# SERVICE BULLETIN

## 2" 3:1 and 3" 5:1 Pump Changes

RELEASED: 3-12-03  
REVISED: 1-10-12  
BULLETIN: #1-03  
REV. E

MODELS AFFECTED: LM2203A-( )-B, LM2305A-( ), WLM2203A-( ), 529( ) and 539( )

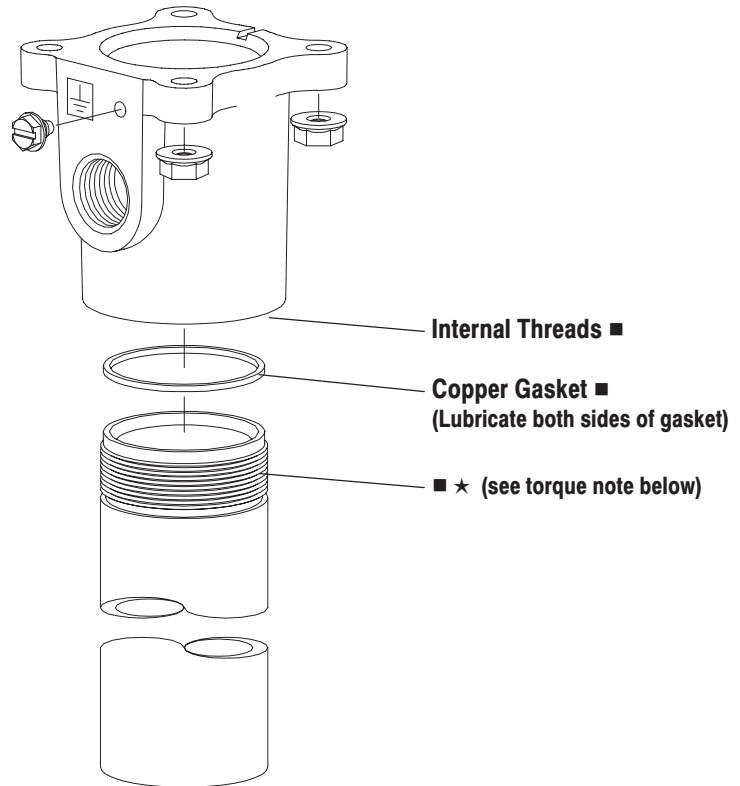
The following changes were made.

- 1.) Replace "O" ring between outlet body and tube with copper gasket.
- 2.) Change effects models built beginning April 21, 2003 (S/N D0213-XXX).

### OLD DESIGN

### NEW DESIGN

- Lubricate with Darina "EP" 2 grease at assembly.

NOTE: Torque to 1 - 2 ft lbs (1.36 - 2.71 Nm), then turn joint an additional 45° - 60°.
